CAPISTRANO UNIFIED SCHOOL DISTRICT BOARD REPORT

Board Item: Change Order No. 1, Bid No. 1819-17, Palisades Elementary School

Modernization Project

CHANGE ORDER

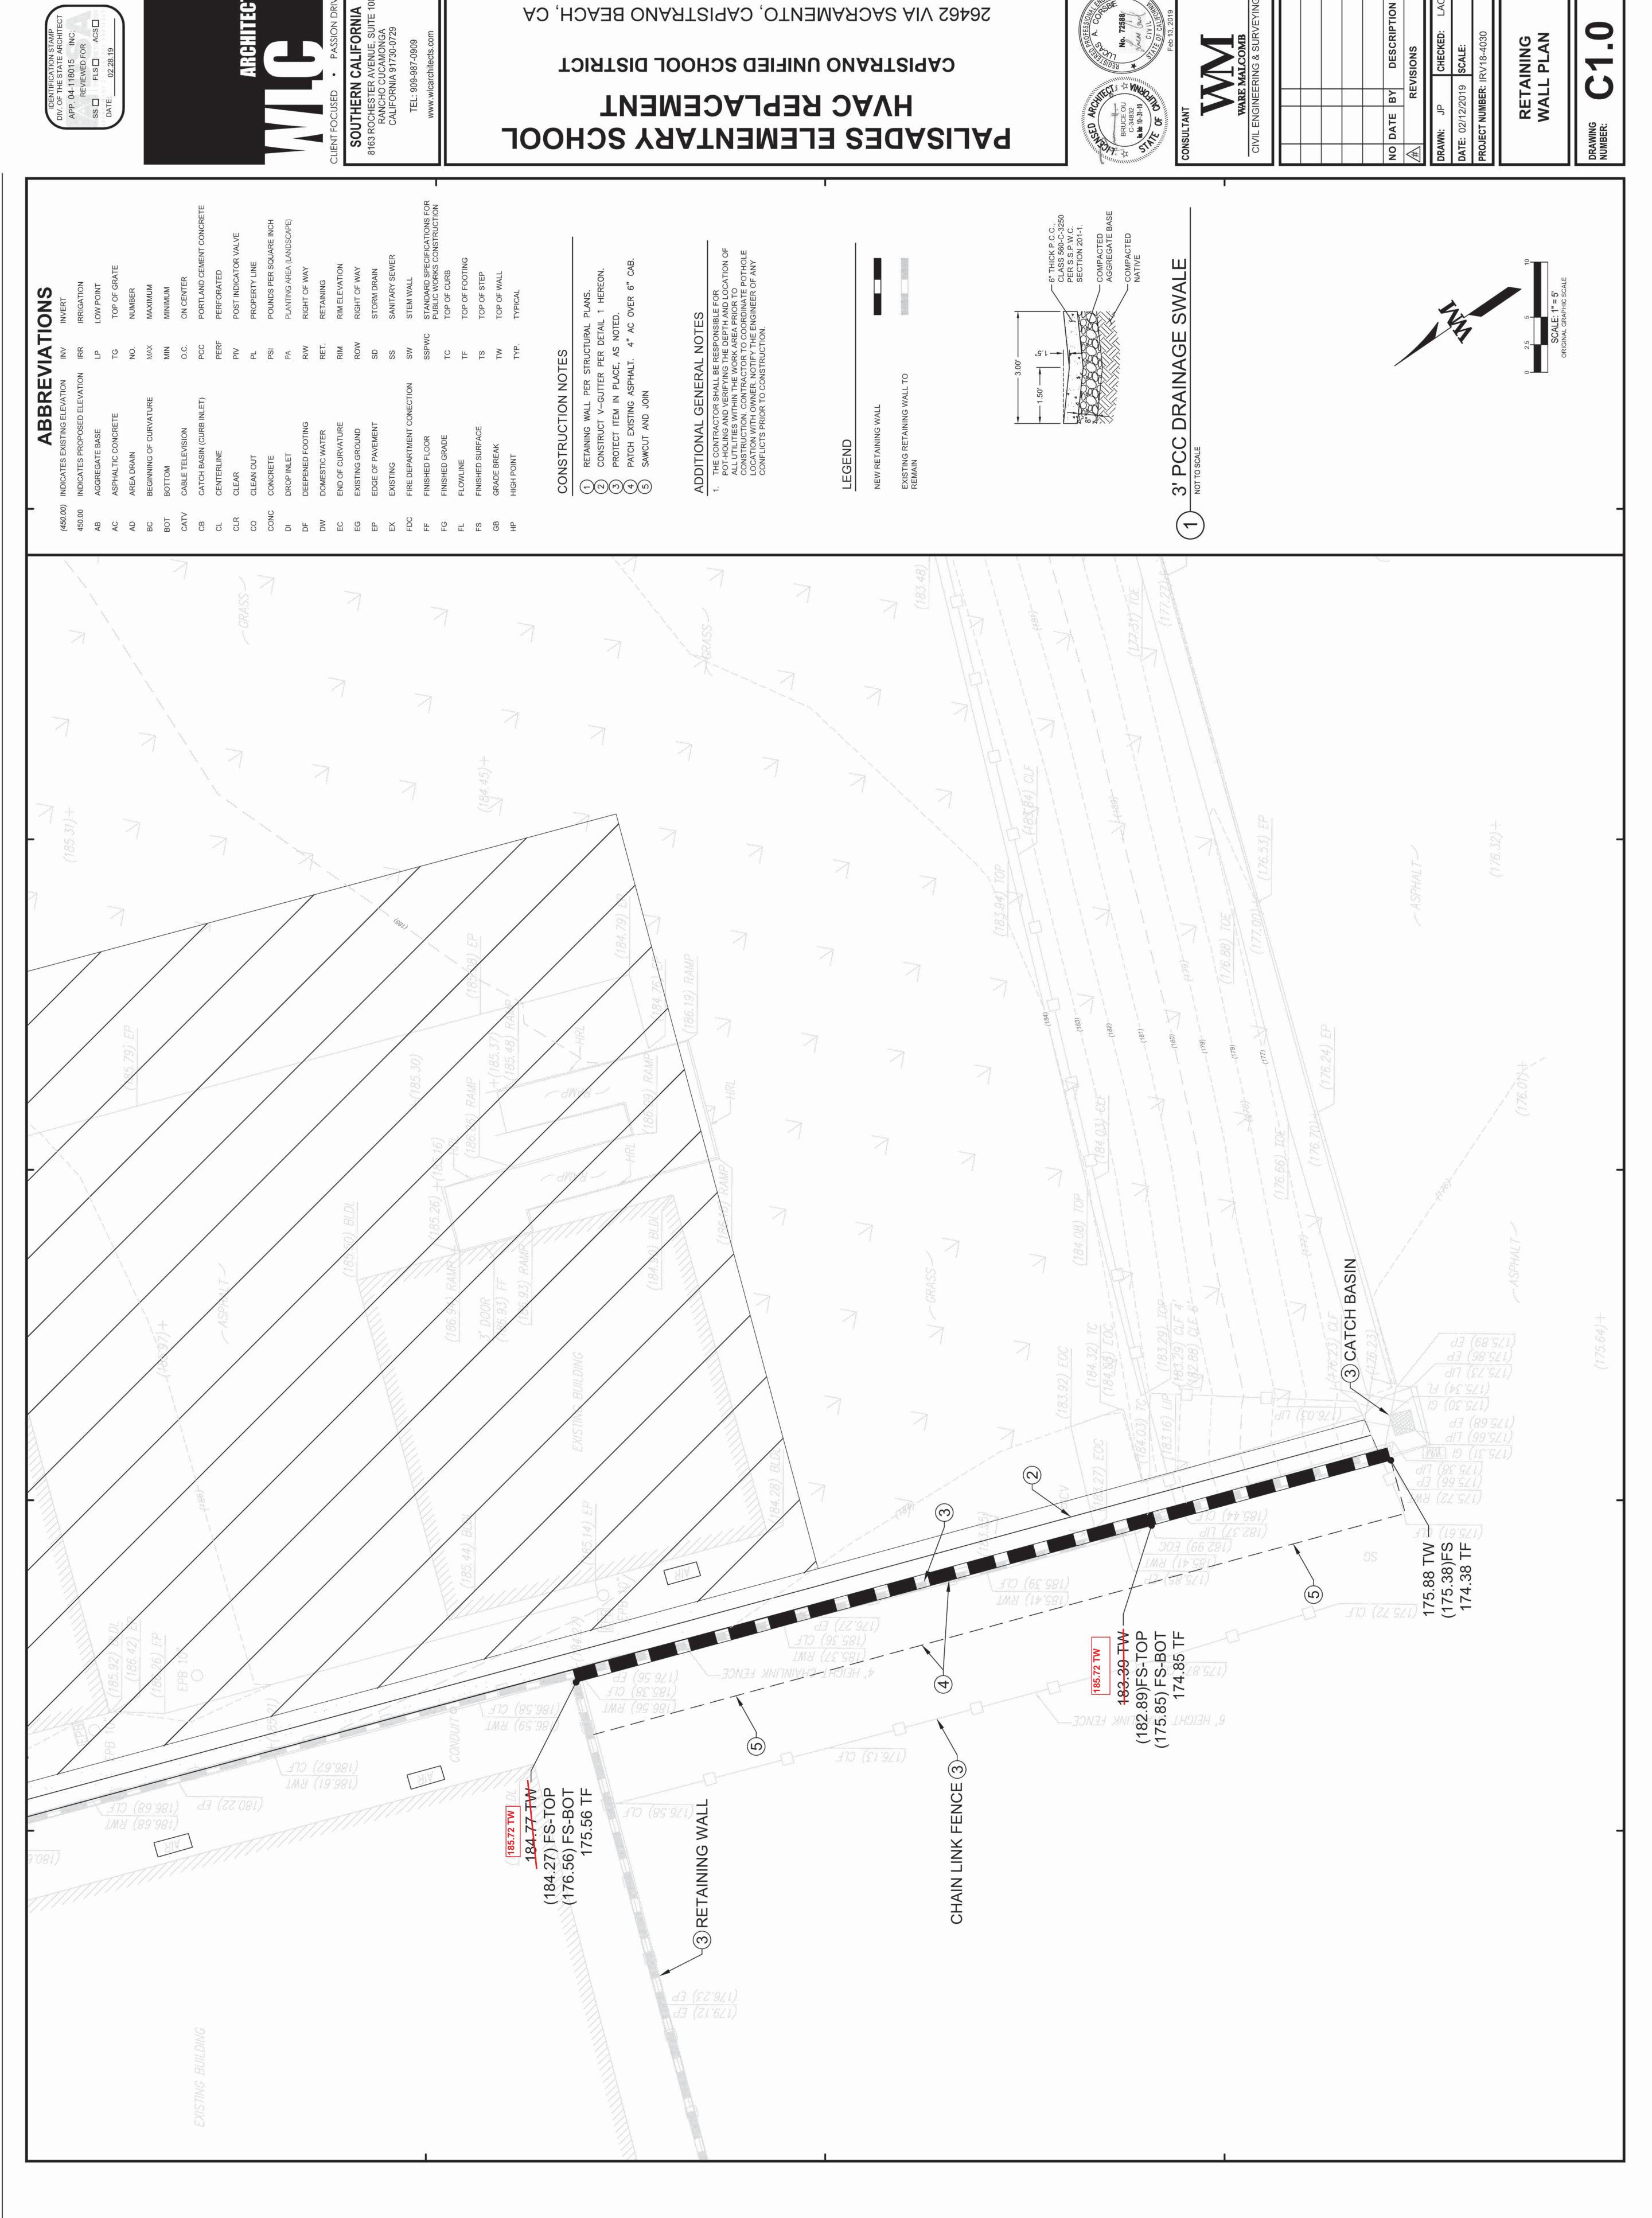
Please see attached RFI from Civil Works, our concrete subcontractor with regards the elevation of top of retaining wall, please confirm.

Confirmed to adjust TW elevation as suggested.

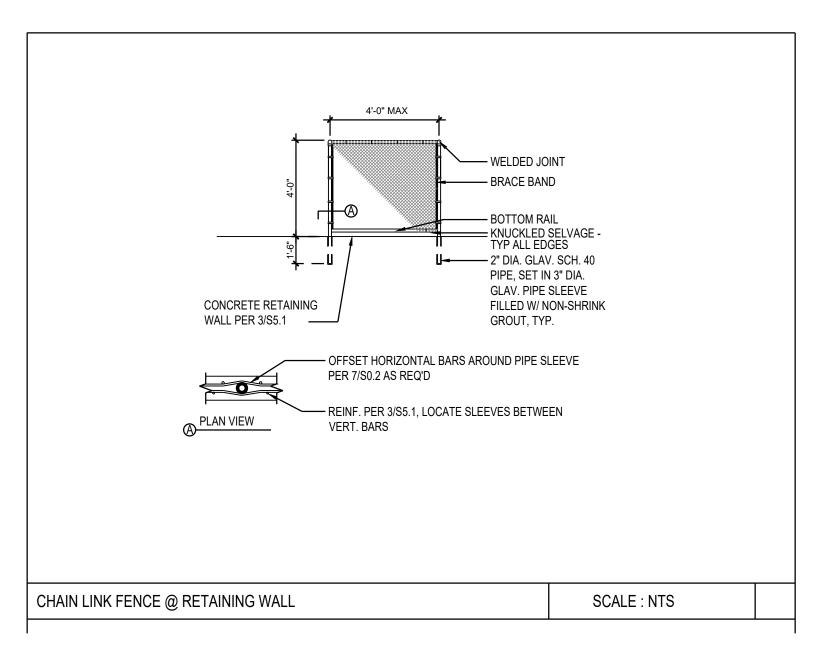
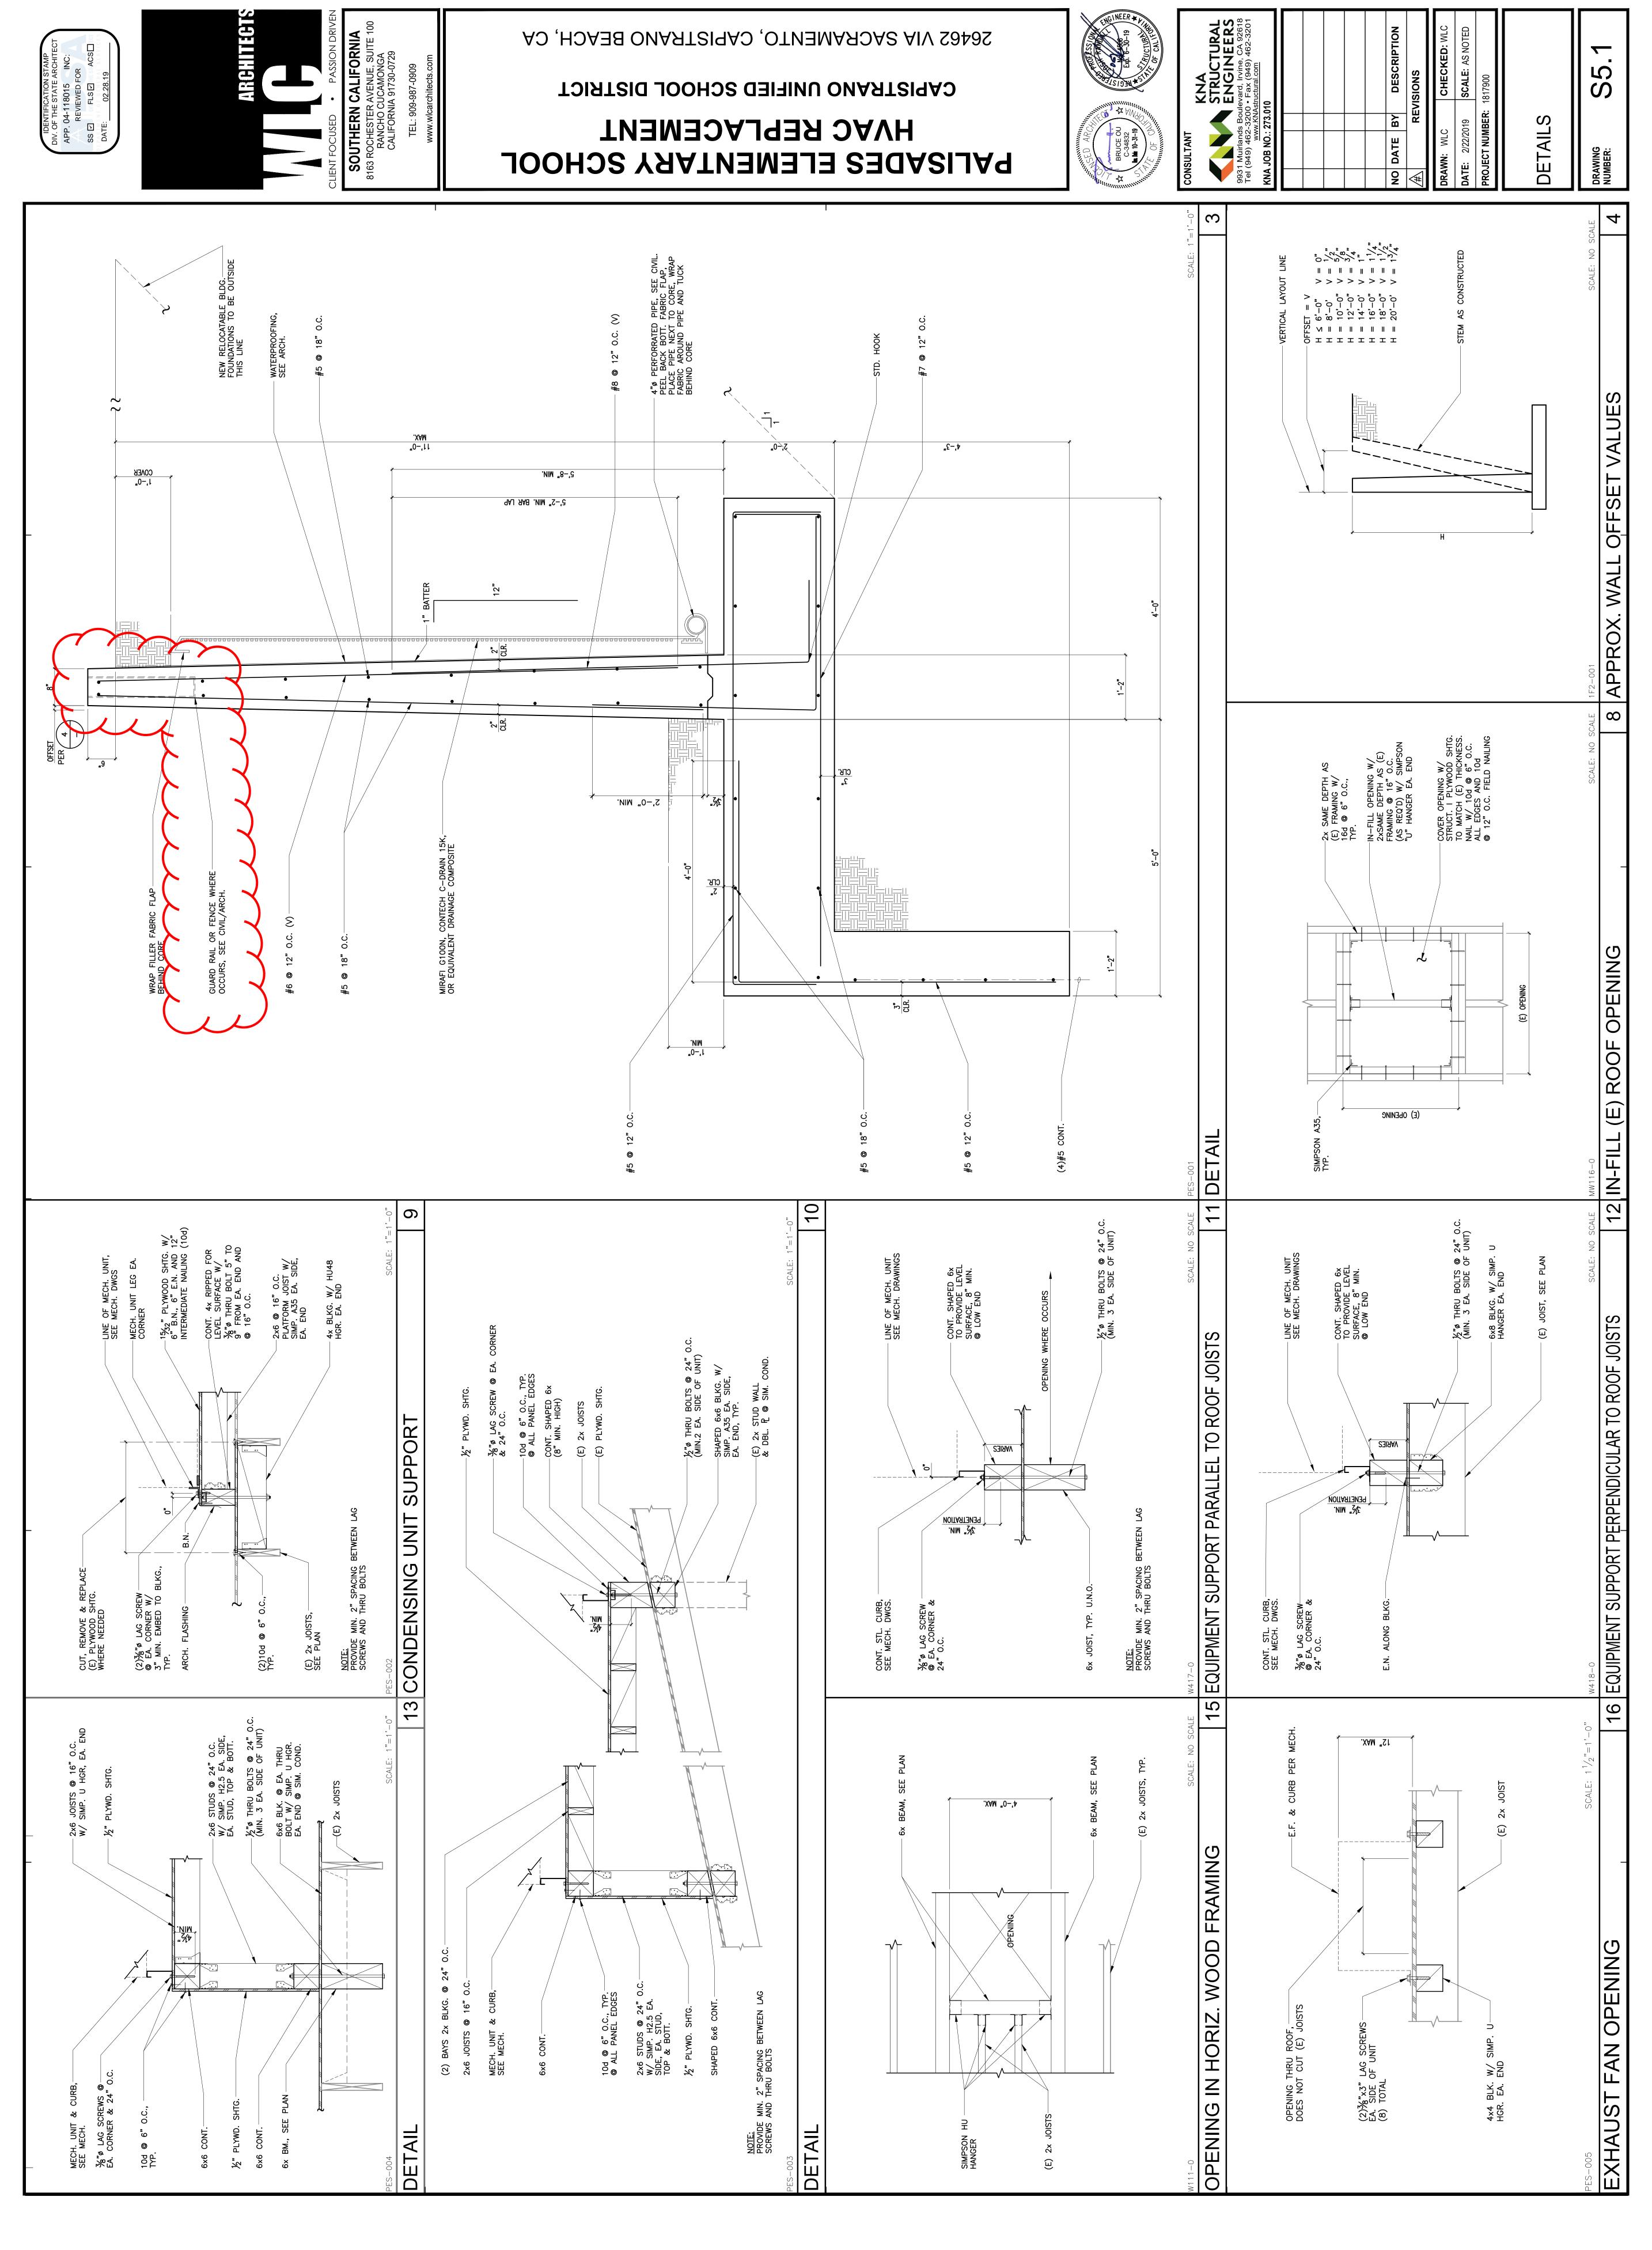
Please refer to attached drawing sheet S5.1 Detail 3, clouded area indicates guard rail/fence per architectural/civil, there is no details in either one, please provide direction on how to proceed. Please note, the plan is to place concrete at retaining wall this coming Friday, please advise ASAP.

Install 4' tall chainlink fence at top of new retaining wall per attached detail, pending DSA approval via CCD. Kathleen Gillette, WLC, 06-05-19

Plan Sheet(s): Sheet EE2.1 Details 1 and 2

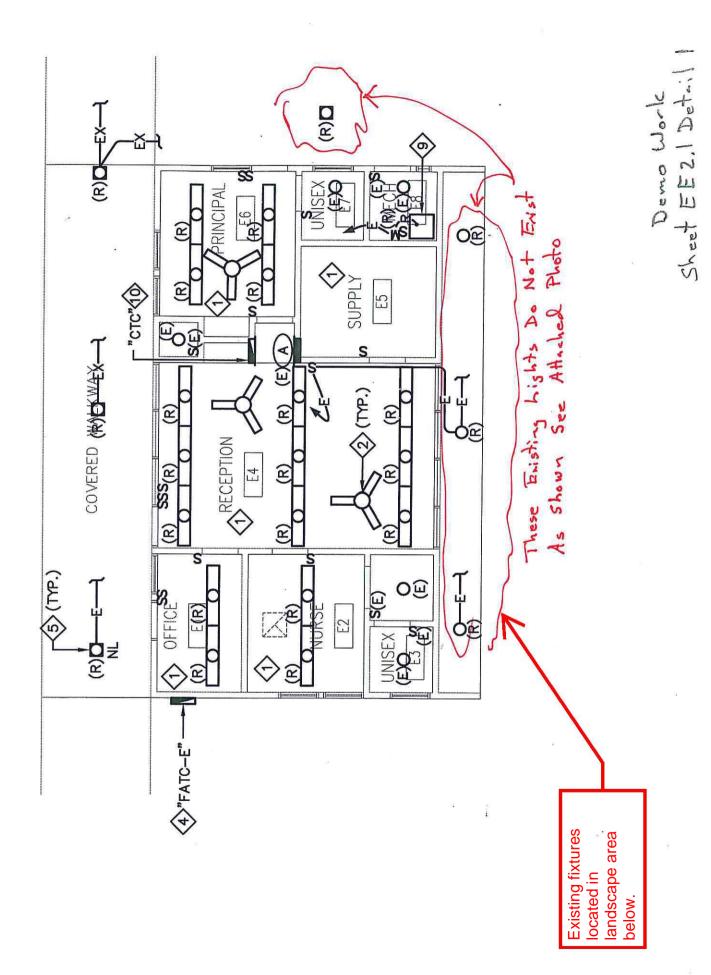
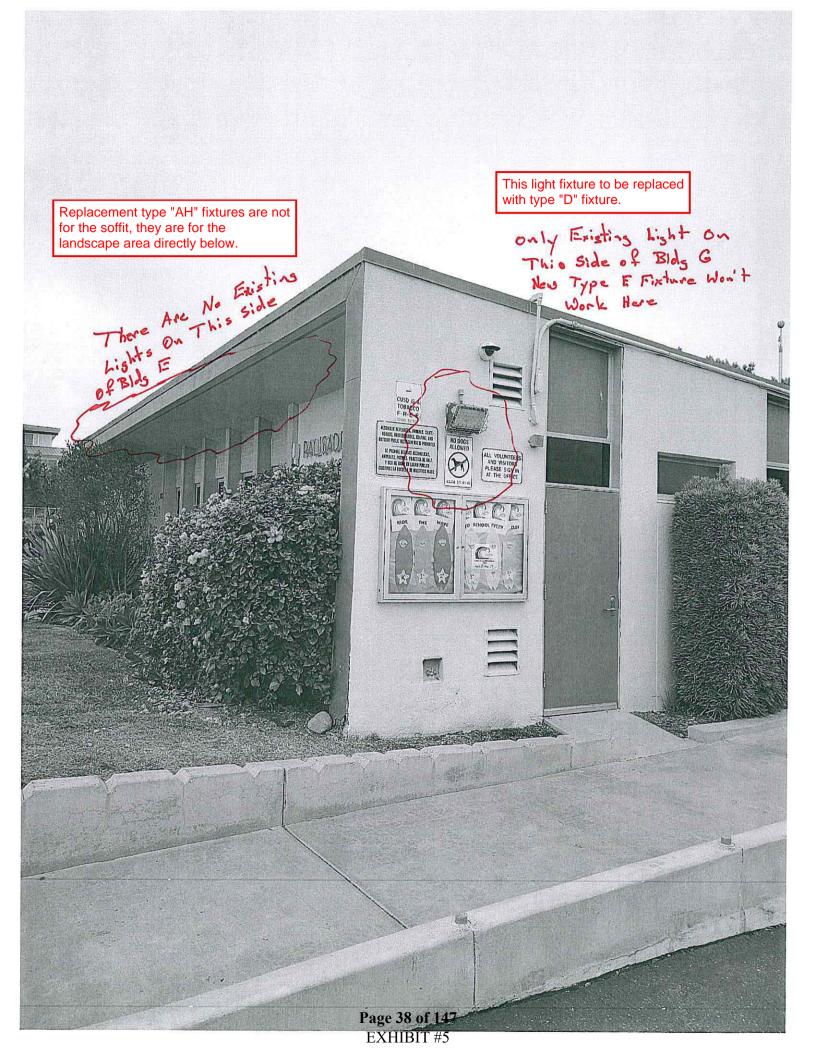
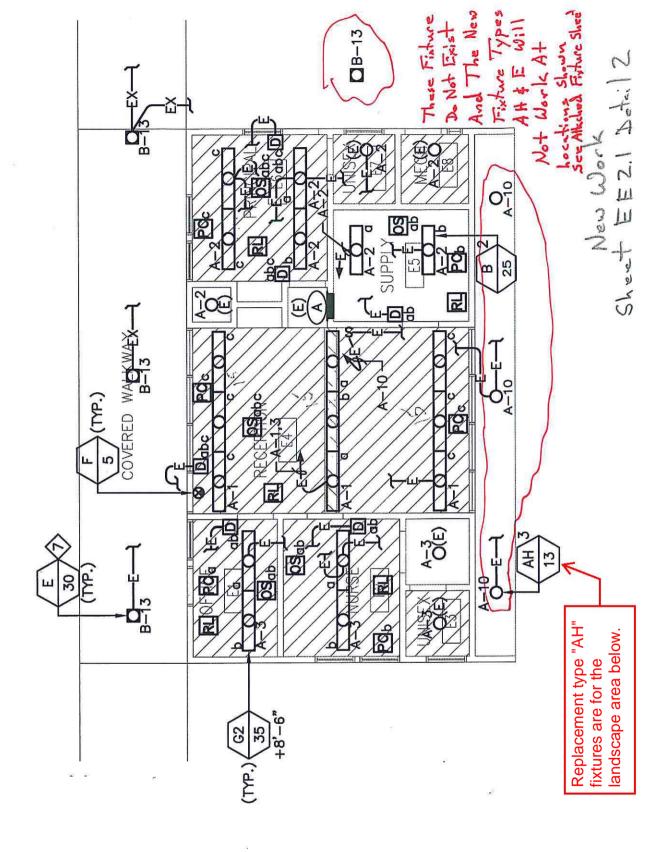
Plan sheet EE2.1 detail 1 shows to remove 4 existing light fixtures in overhead soffits and replace them with new fixtures. But these light fixtures do not exist. And there is no existing soffit where the single light fixture is shown (see photo) it is a wall mounted fixture. The new light fixture types shown to replace these existing fixtures will not work and there is no existing wiring and J boxes for these locations.

Please provide direction Do nothing and turn over fixtures to owner, change just the existing wall mounted fixture with LED wall mount fixture cost impact for different fixture, Install new wiring and j boxes at the location of the 3 fixtures and install the approved type AH at these 3 locations for an additional cost.

Fixture type "AH" was never intended for a soffit application; it is for the replacement of (E) landscape fixtures at bldg. E.
